# **Technical Note**

# Victoria House

Job Number: 100555	Date: 28 March 2023	Client: Oxford Victoria House Limited
Prepared By: CW	Approved By: SG

2.1. The following comments have been made in respect to the AQA.

Figure 2: Close up of Victoria House with building tier heights and source and receptor locations

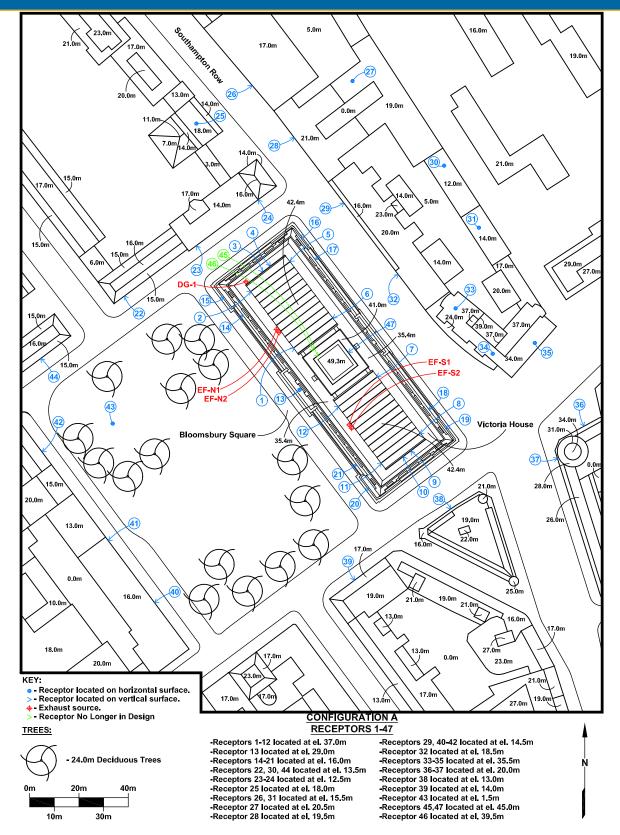
"Figure 3.3 indicates that the fume cupboard flues are quite close to air inlets RC, RG and RH and the prevailing wind direction from 2 flues are towards inlet RD. Relocation of these inlets is recommended or further details including the distance and cross-sectional diagrams of the exhausts / flues and inlets (to show location and relative heights) are required to ensure that there is no recirculation of emissions.

2.2. We understand that a detailed wind tunnel survey was carried out to obtain accurate concentration estimates at building air intakes and other sensitive locations due to emissions from the proposed laboratory extract sources located on the Victoria House. The CCP (2022) *Final Air Quality Report. Victoria House* report<sup>1</sup>, which was appended to the KJ Tait's MEP report, has now been updated and is appended to this TN. The CPP (2023)<sup>2</sup> report concluded that all of proposed inlets modelled will meet the ASHRAW criterion (as outlined on page 3). Standard 62.1 of ASHRAW:

- 2.3. It is, however, noted that the CCP report summaries that the ASHRAE criterion is not met at some rooftop air intakes for less than 1% of wind conditions; this is typically considered an acceptable risk of exceedance.
- 2.4. On this basis, the air inlets modelled in line with drawing no. KJT-ZZ-R-DR-M-5701 meet the ASHRAW criterion "to provide indoor air quality (IAQ) that's acceptable to human occupants and that minimizes adverse health effects."
